## ELECTRICAL SAFETY PROVISIONS FOR VEHICLES Post Crash

Draft agreed during 8<sup>th</sup> ELSA Meeting

Figure 1 Measurement of  $V_b$ ,  $V_1$ ,  $V_2$

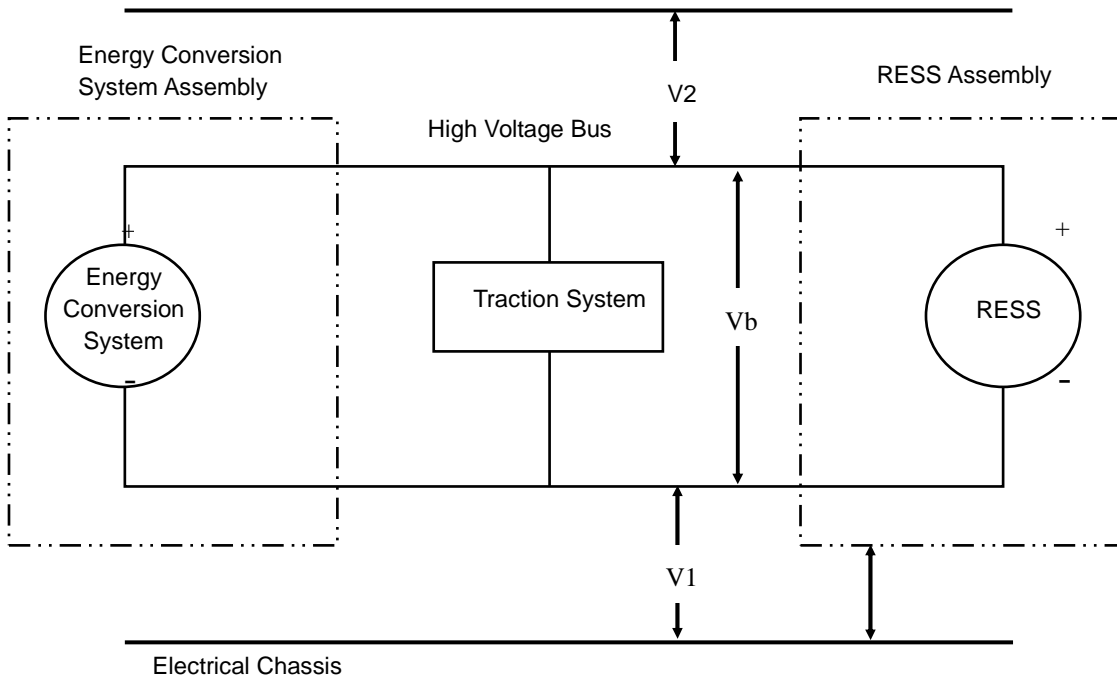
After the impact test, determine the high voltage bus voltages ( $V_b$ ,  $V_1$ ,  $V_2$ ) (see figure 1).

~~Voltage measurement. For the purposes of determining low voltage source specified in S5.3(b), voltage is measured as shown in Figure 1. Voltage  $V_b$  is measured across the two terminals of the voltage source. Voltages  $V_1$  and  $V_2$  are measured between the source and the vehicle chassis electricity-conducting structure.~~

Measure and record the voltage (Vb) between the negative and the positive side of the high voltage bus (see figure 1);

Measure and record the voltage (V1) between the negative side of the high voltage bus and the electrical chassis (see figure 1);

Measure and record the voltage (V2) between the positive side of the high voltage bus and the electrical chassis (see figure 1);

Figure 3: Measurement of V1'

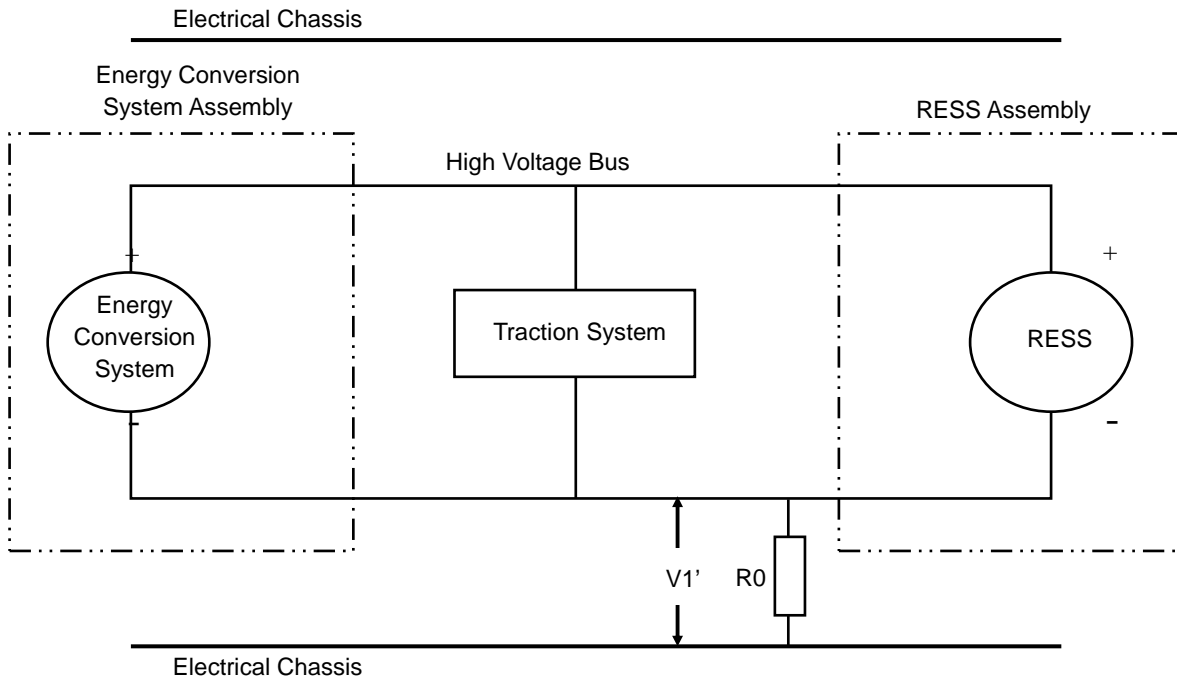
~~S7.6.6 If V1 is greater than or equal to V2, insert a known resistance (Ro) between the negative side of the high voltage source and the vehicle chassis electricity-conducting structure. With the Ro installed, measure the voltage (V1') as shown in Figure 4 between the negative side of the high voltage source and the vehicle chassis electricity-conducting structure. Calculate the electrical isolation resistance (Ri) according to the formula shown. Divide Ri (in ohms) by the working voltage of the high voltage source (in volts) to obtain the electrical isolation (in ohms/volt).~~

If V1 is greater than or equal to V2, insert a standard known resistance (Ro) between the negative side of the high voltage bus and the electrical chassis. With Ro installed, measure the voltage (V1') between the negative side of the high voltage bus and the vehicle electrical chassis (see figure 3). Calculate the isolation resistance (Ri) according to the formula shown below.

$$R_i = R_o \cdot (V_b / V1' - V_b / V1) \quad \text{or} \quad R_i = R_o \cdot V_b \cdot (1 / V1' - 1 / V1)$$

**Figure 4: Measurement of  $V_{2'}$**

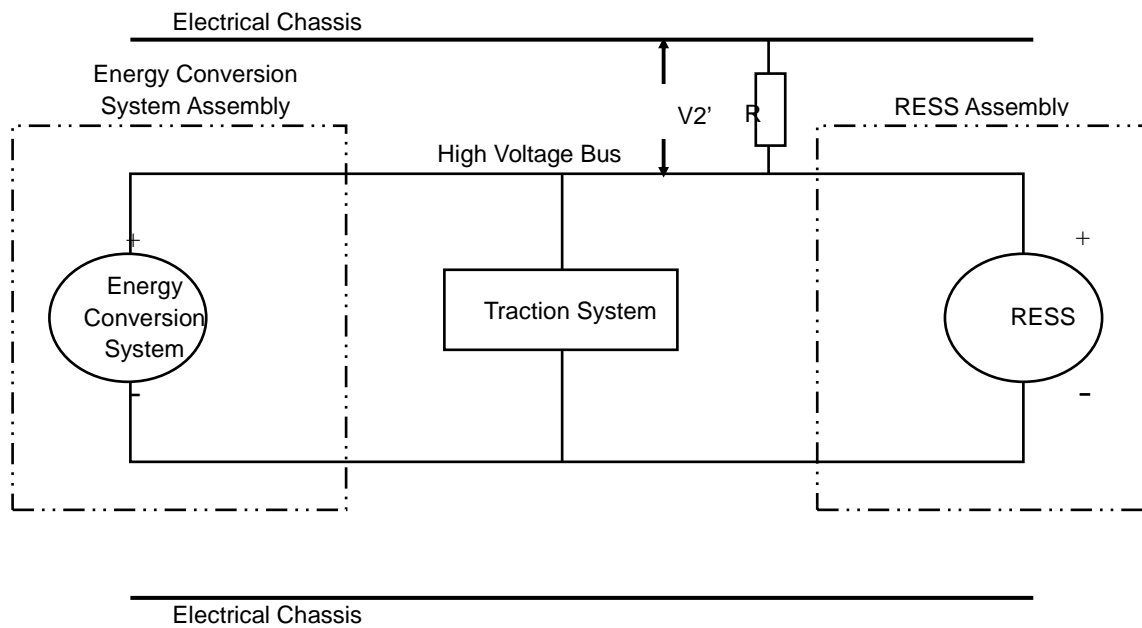
~~S7.6.7 If V2 is greater than V1, insert a known resistance (Ro) between the positive side of the high voltage source and the vehicle chassis electricity-conducting structure. With the Ro installed, measure the voltage (V2') as shown in Figure 5 between the positive side of the high voltage source and the vehicle chassis electricity-conducting structure. Calculate the electrical isolation resistance (Ri) according to the formula shown. Divide Ri (in ohms) by the working voltage of the high voltage source (in volts) to obtain the electrical isolation (in ohms/volt).~~

If V2 is greater than V1, insert a standard known resistance (Ro) between the positive side of the high voltage bus and the electrical chassis. With Ro installed, measure the voltage (V2') between the positive side of the high voltage bus and the electrical chassis (see figure 4). Calculate the isolation resistance (Ri) according to the formula shown below.

$$R_i = R_o \cdot (V_b / V_2' - V_b / V_2) \quad \text{or} \quad R_i = R_o \cdot V_b \cdot (1 / V_2' - 1 / V_2)$$

Figure 2: E.g. measurement of high voltage bus energy stored in X-capacitors

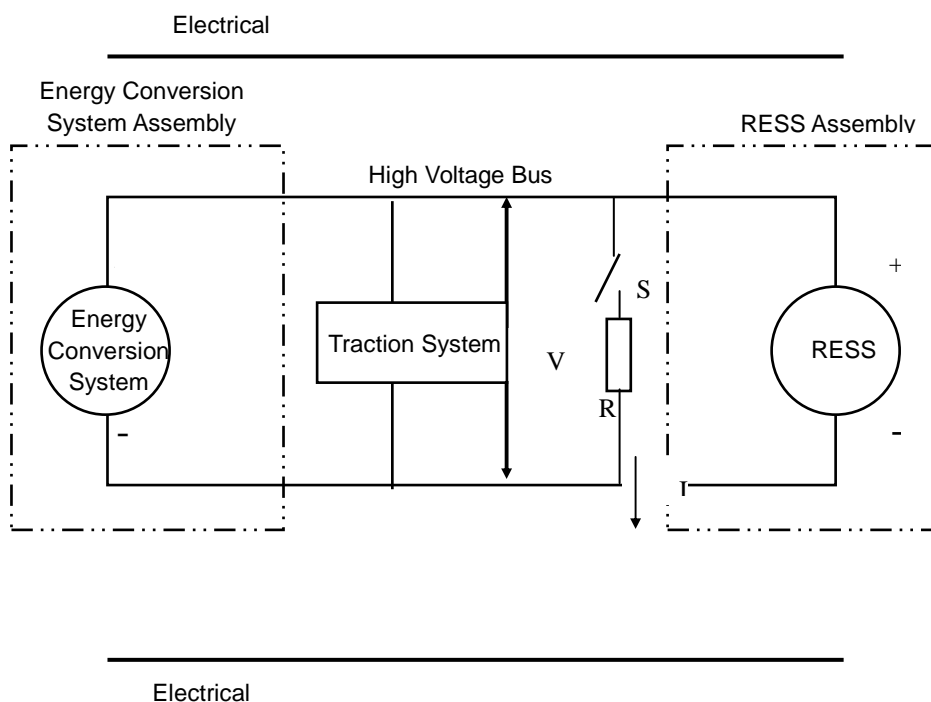
Prior to the impact a switch S1 and a known discharge resistor Re is connected in parallel to the relevant capacitance (ref. figure 2).

The product of the voltage Vb and the current Ie shall be integrated over the period of time, starting from the moment when the switch S1 is closed (tc) until the voltage Vb falls below the high voltage threshold of 60 V DC (tn). The resulting integration equals the total energy (TE) in joules.

(a) 
$$TE = \int_{t_c}^{t_n} V_b \times I_e dt$$
